SECTION III – PLANNING ANALYSIS AND RECOMMENDATION: Disapproval

09-034 CDD
Corridor Development District
Shoppes at River Ridge - Montgomery Inn
4565 West Dublin-Granville Road

PROPOSED FENCE ELEVATIONS

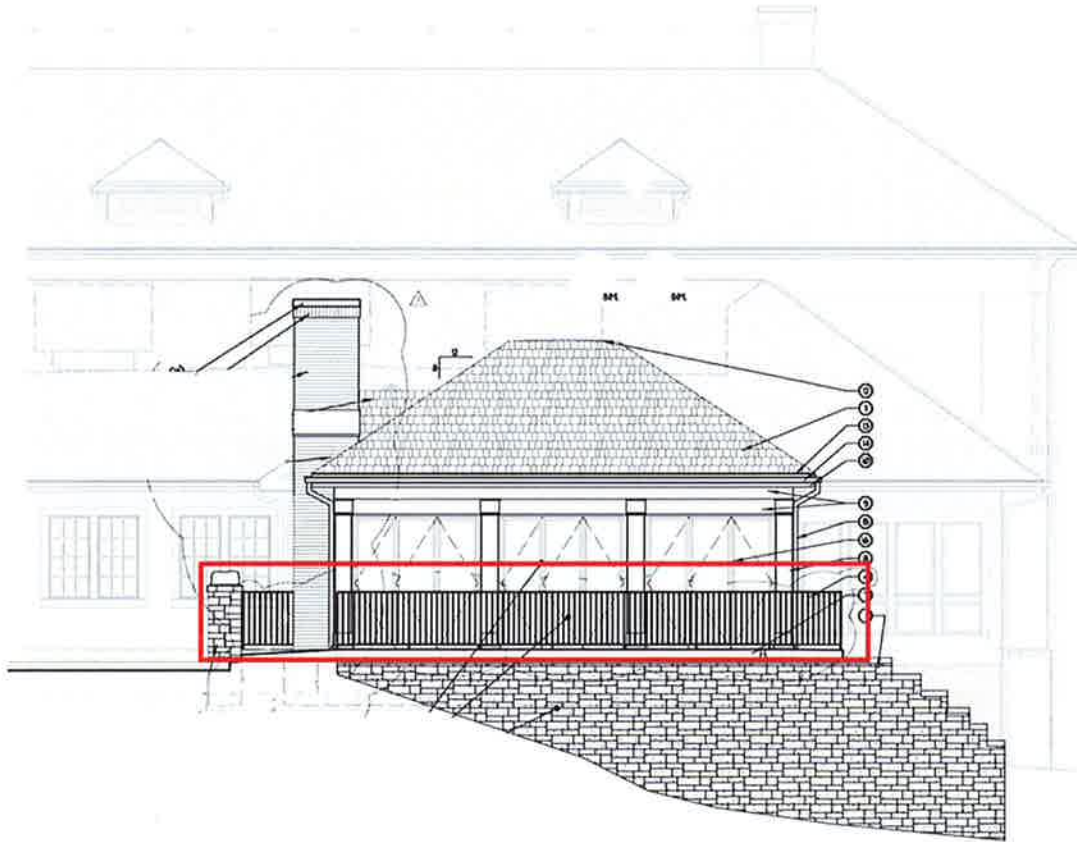
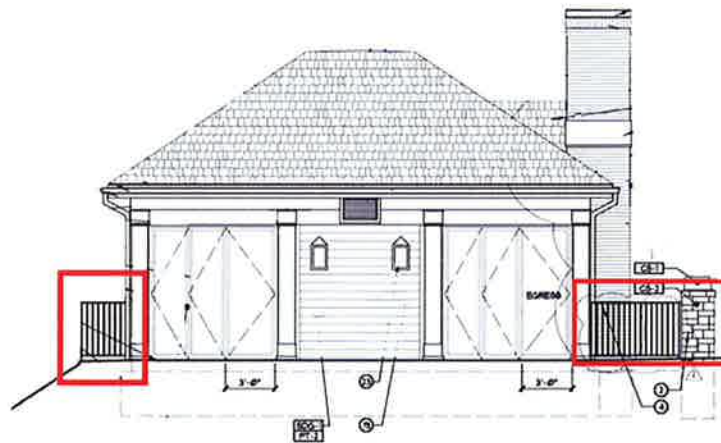
The main restaurant was approved with a white, fiberglass balustrade fence with decorative pickets that encloses portions of the building, mainly along the front (west) side of the building, oriented toward the parking lot. The patio structure was approved with the same fence design and materials. The proposed fencing is white metal railing with plain ½-inch by ½-inch pickets.

The Zoning Code requires that designs of new structures and additions to existing structures in the Corridor Development District coordinate with the general design, material, and architectural style of their surroundings. The Code also specifies that evaluation of the appearance of a project shall be based on the design quality and its relationship to its surroundings. The proposed fencing material, which consists of a plain white metal railing, is incompatible with the more detailed design of the fencing installed around the main restaurant and is distinctly different from what was originally approved for the patio structure.

It is Planning's opinion that because the proposed fencing is inconsistent with existing fencing on the site and because it does not achieve the aesthetic purposes of the originally approved fencing, the review criteria for this proposal has not been met.
